REVISION TO
HENRY AFRICA SUBDIVISION
 ROCKWALL TEXAS

SITE PLAN REVIEW

Name of Proposed Development Henry Africa / Oak House

Agenda Item: 91-41-SP/CUP - Discuss and Consider Recommending Approval of a Revised Site Plan for the Henry Africa Addition and an Expansion for the Existing CUP

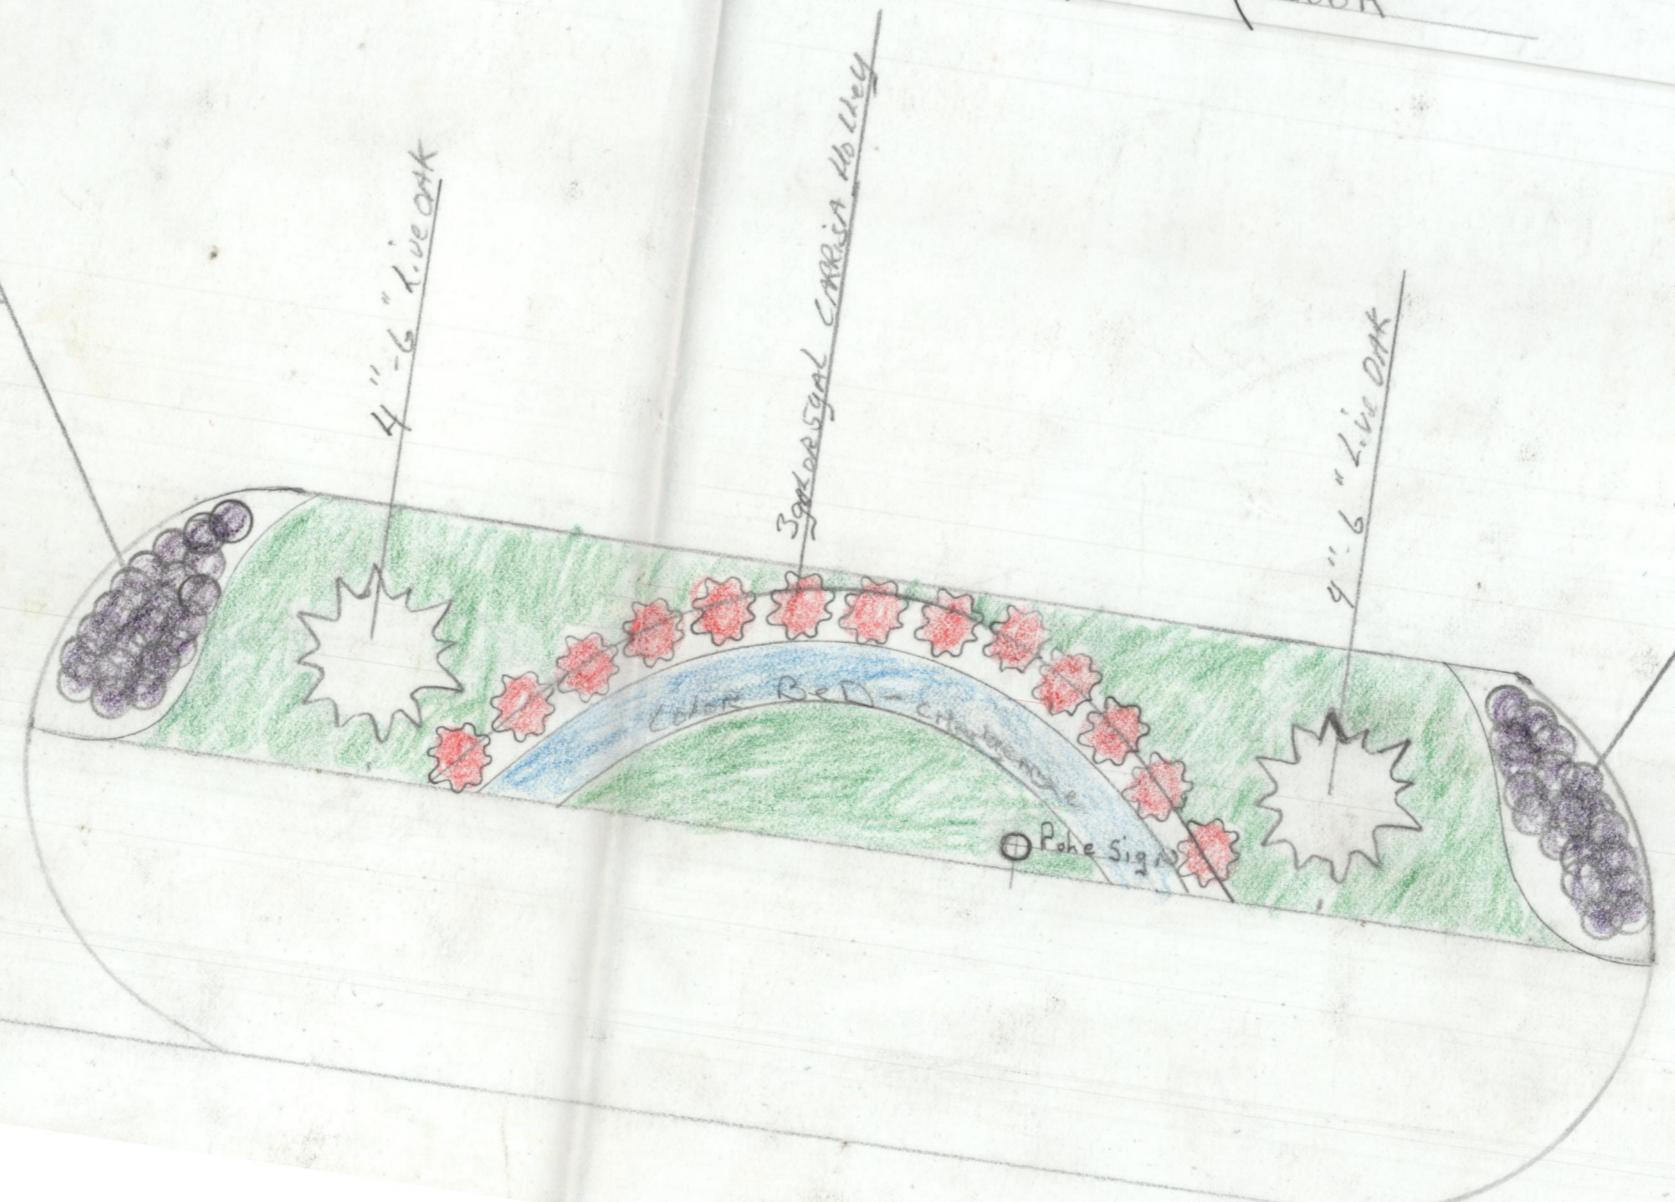
When new RESTAURANT is completed I THINK IT would be nice to EXTEND THE WALKWAY TO RESTAURANT

There are several existing trees along creek with there is no suitable method to show them off. We should hang baskets and possibly plant some small hardy vines on them. Plant display

Existing 6' wide walkway - should be widened to 8' and have railing

Exhibit "A"

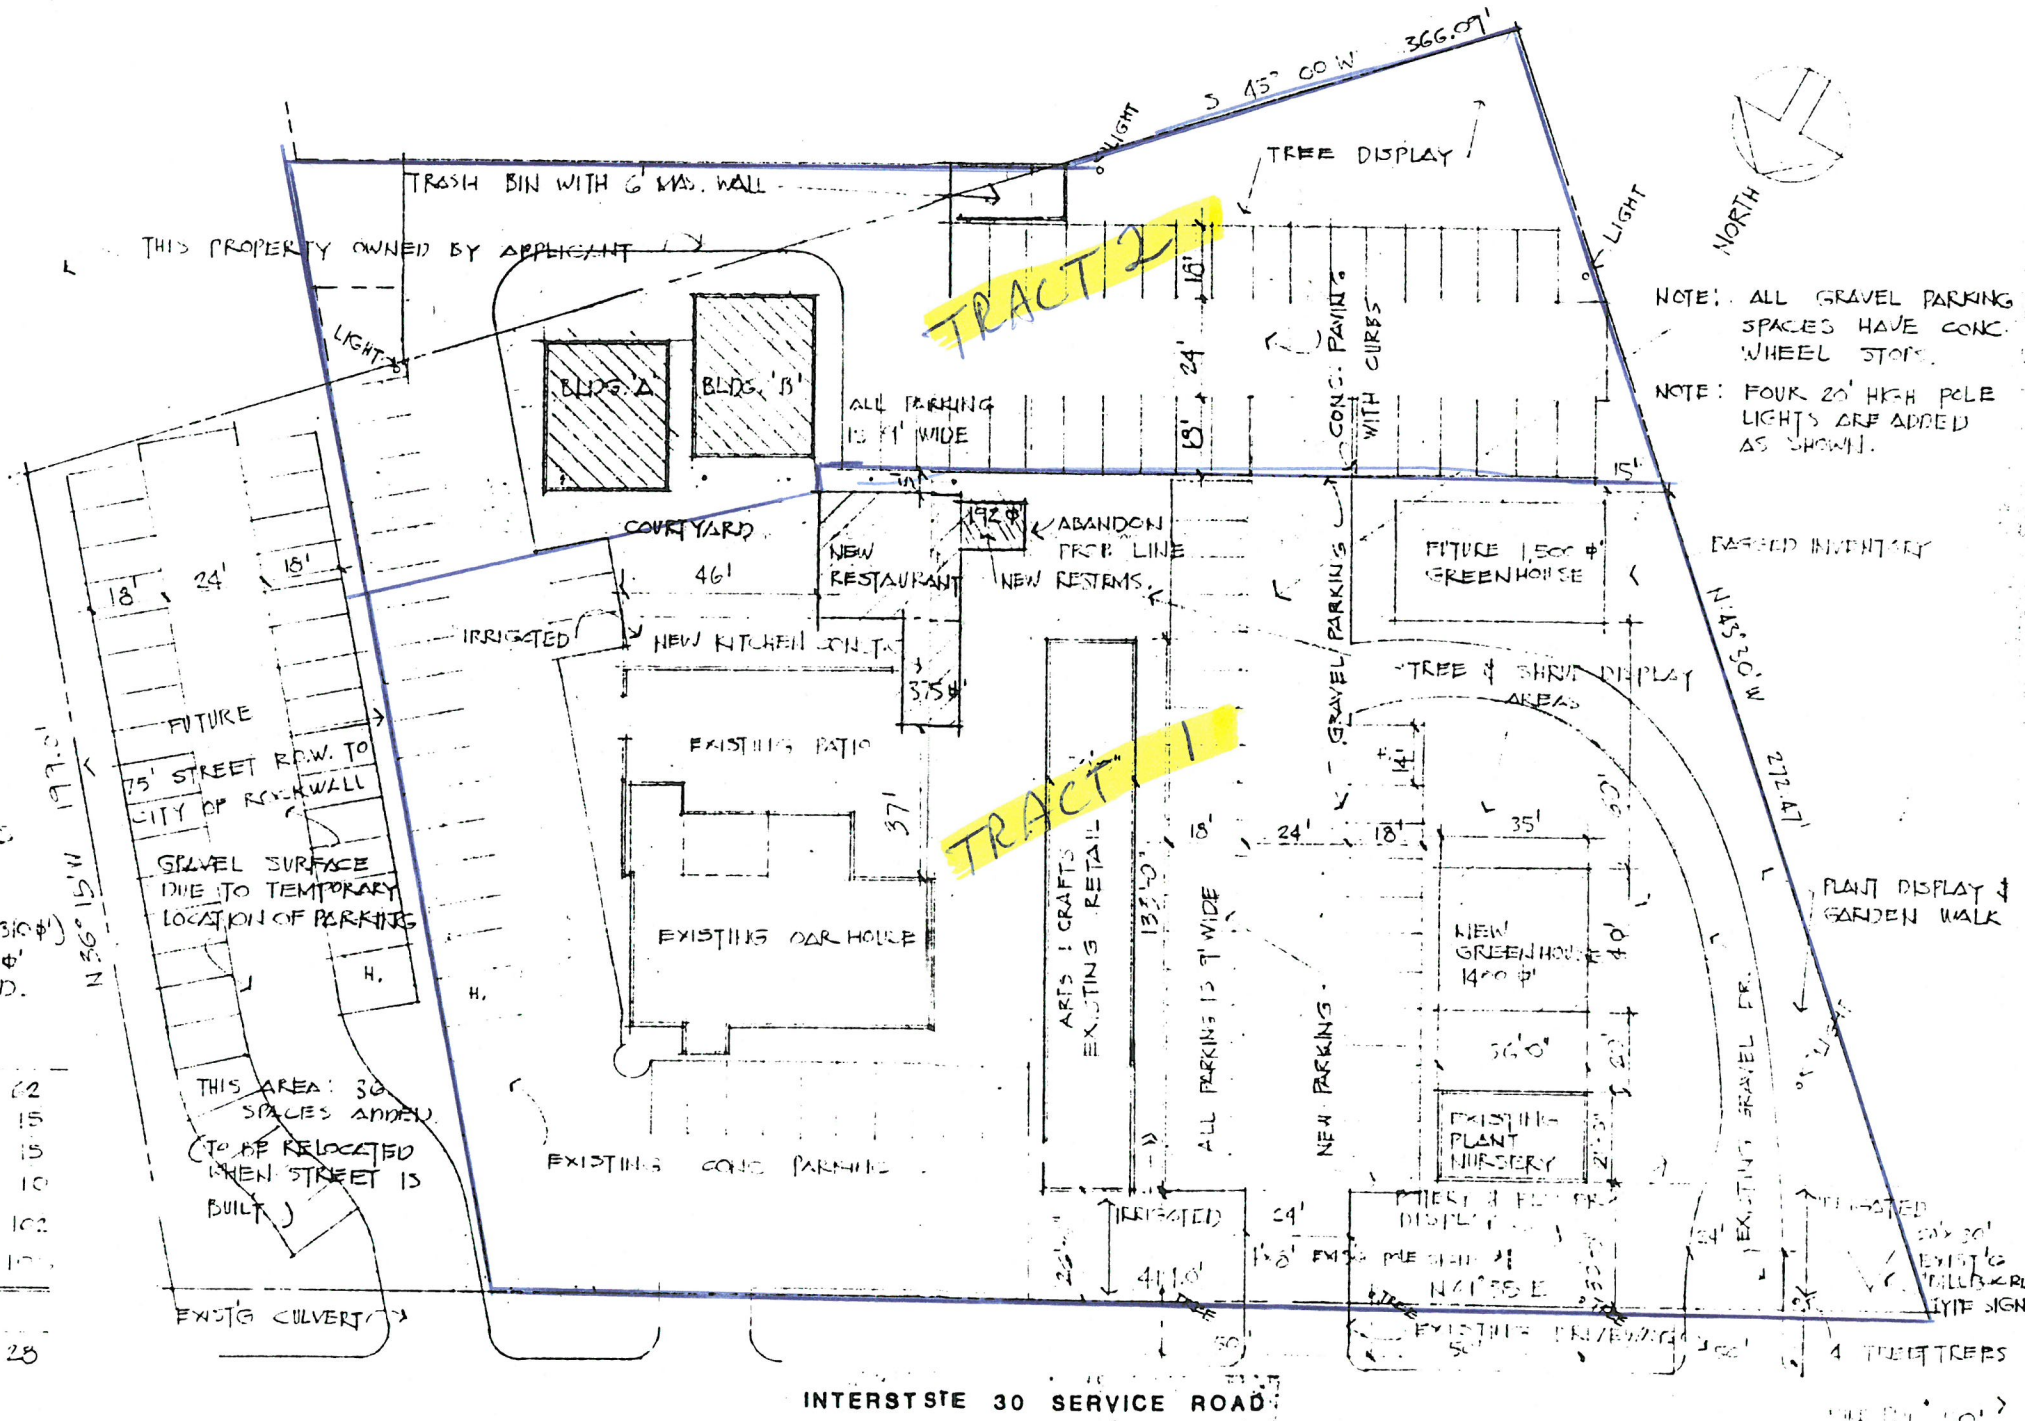
1. need to show square footage for area defined in agreement. Total area imagined = 64,476 sq ft need 15% 9,671
shown on plan 4,621
2. need plan for in front of our house
- 3.

REVISION TO
HENRY AFRICA SUBDIVISION
 ROCKWALL TEXAS

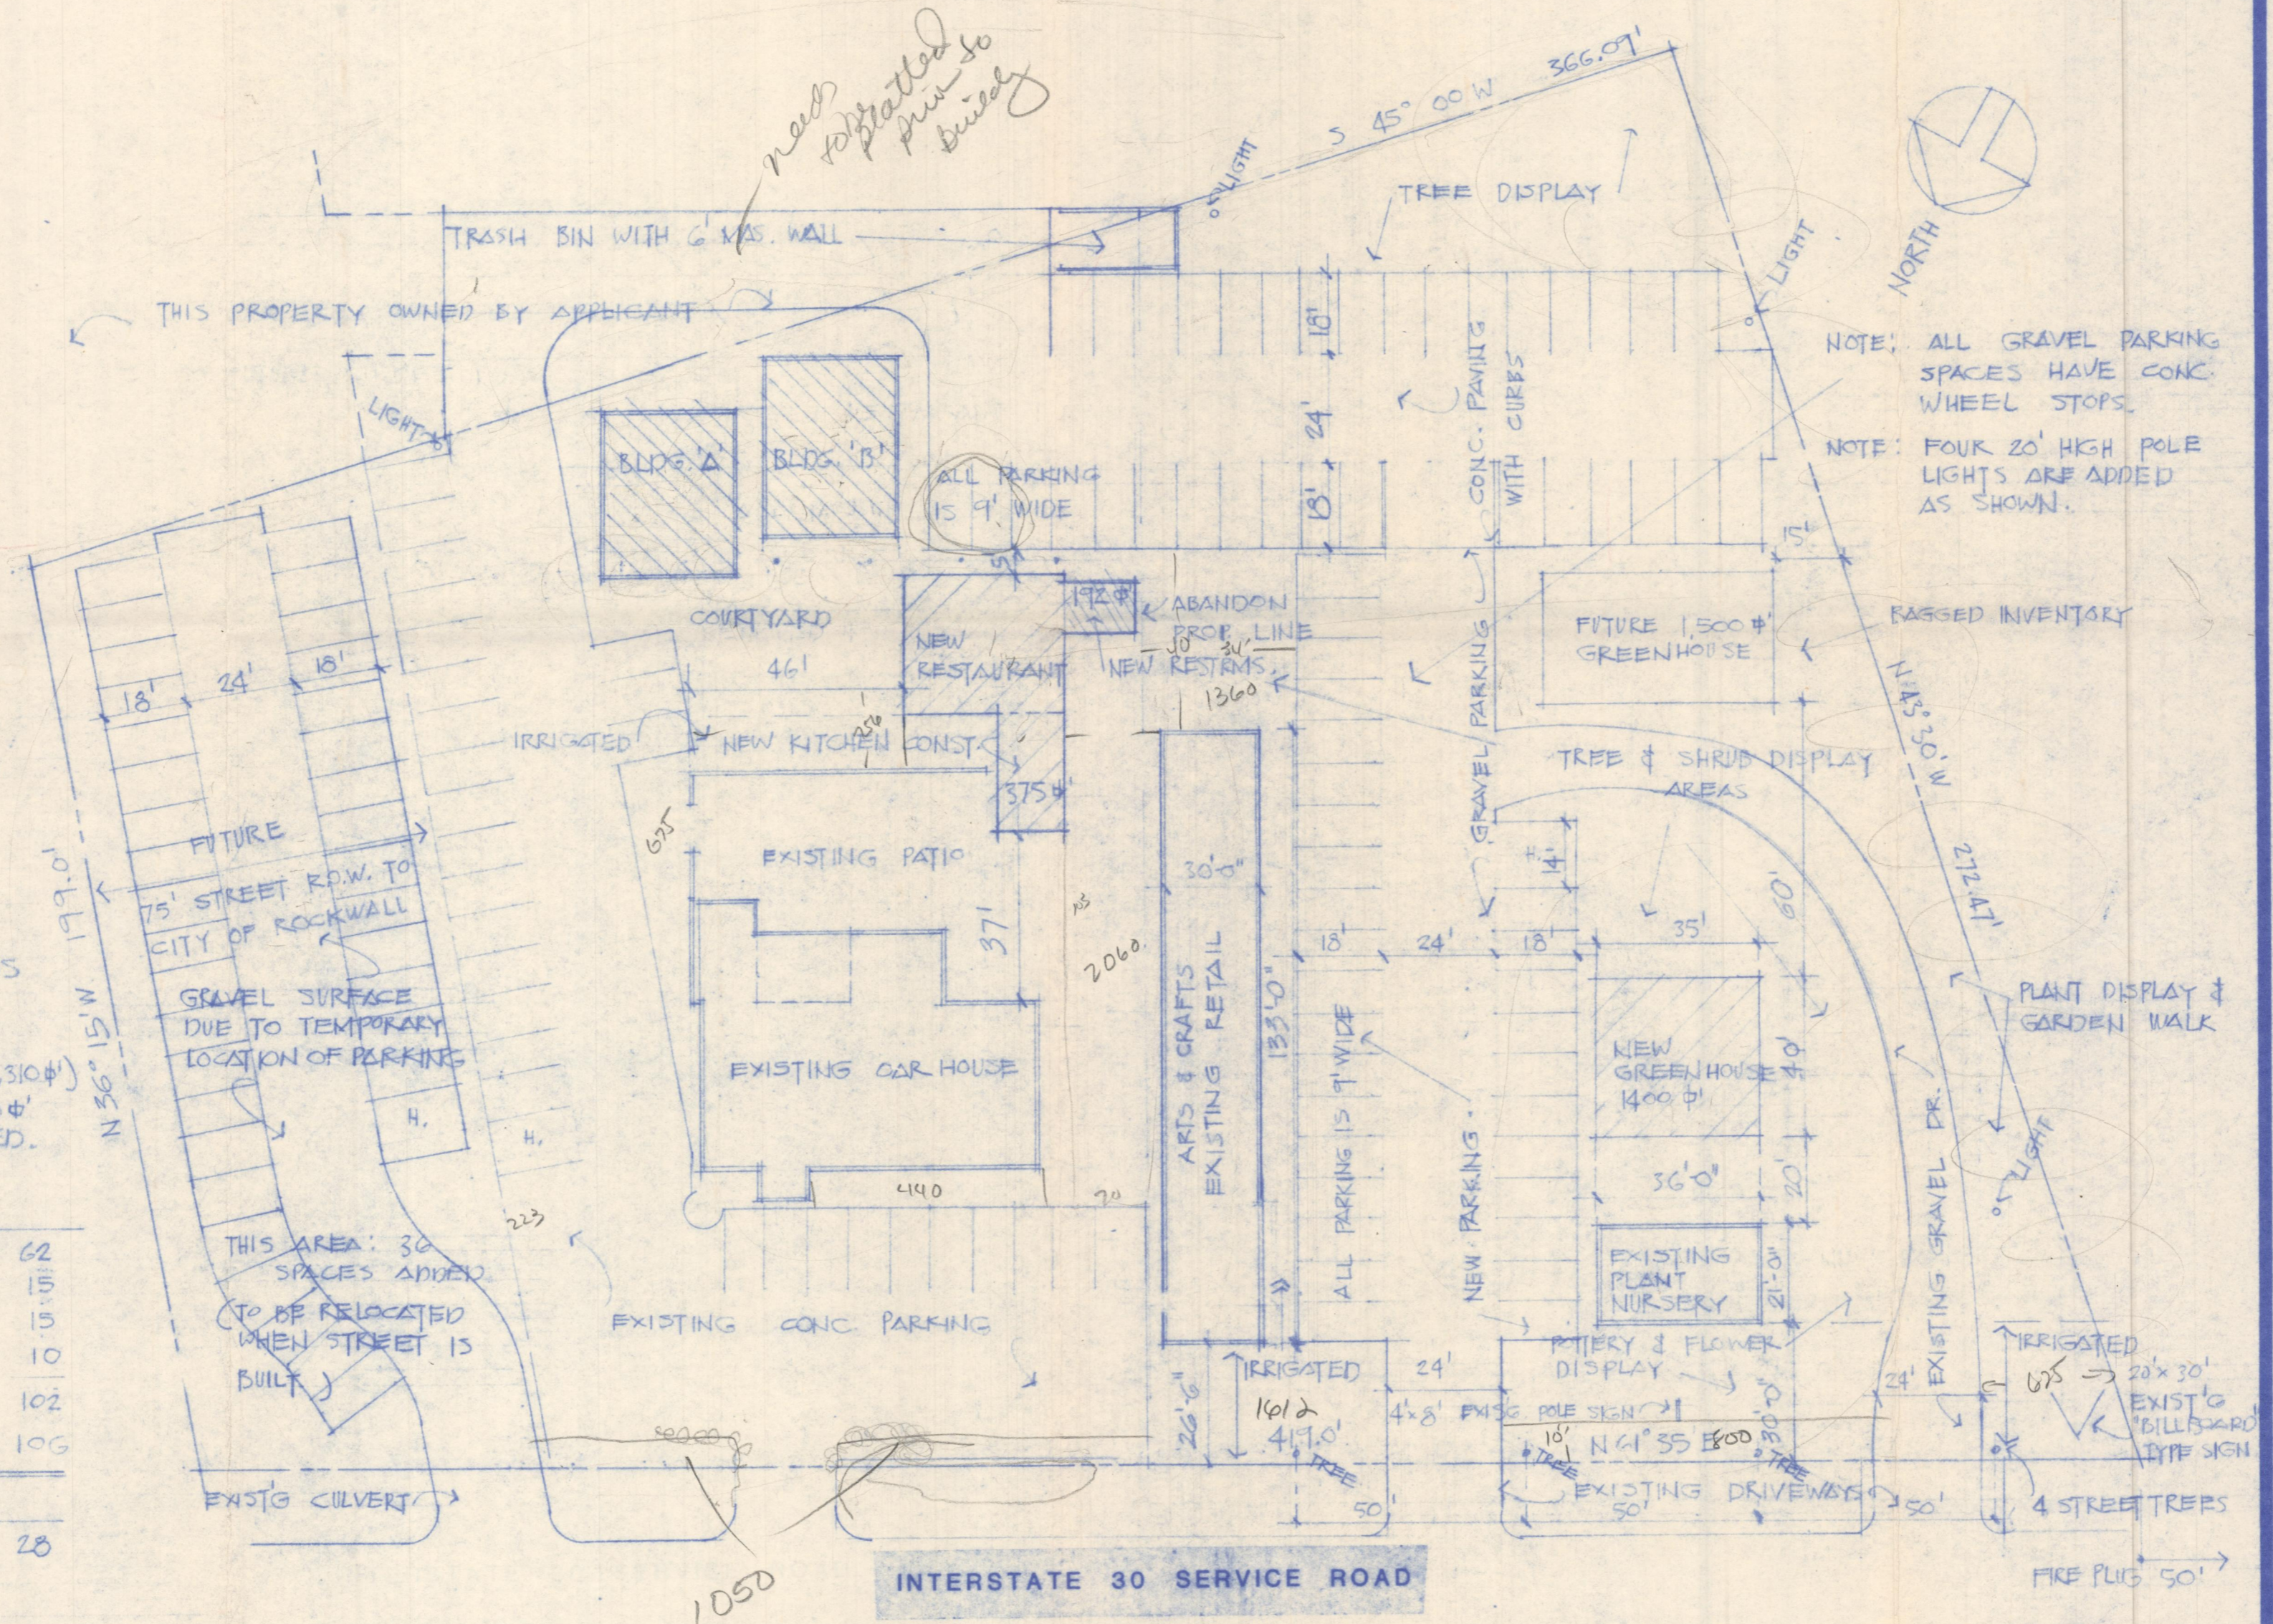
On the site plan you will notice that the applicant included parking on the space reserved for the future ramp. When he prepared this plan it was not yet known that the State would be starting on I-30 as soon as they are and he had wanted to use the area for temporary parking. Because the road improvement is imminent the applicant will build the required parking adjacent and to the south of the Henry Africa Addition. He has not shown that parking because he does not yet know the configuration of land that will be available until the alignment of the street the City will build to replace the service road is finalized. The staff is currently in the process of working on the alignment. Once we have heard back from the State regarding our proposed alignment the parking can be constructed.

- a. That the area south of the Henry Africa Addition to the future city road to be constructed parallel to I-30 be platted into the Henry Africa Addition upon determination and approval of the ramp and road alignment by the City and the State.
- b. That a parking plan be submitted and in place prior to the issuance of a Certificate of Occupancy for either new building.
- c. That a detailed landscaping plan be submitted and approved prior to the issuance of a Certificate of Occupancy for any building on the site.
- d. That the other new building other than the Helping Hands building be submitted for approval by the Commission prior to construction or relocation.
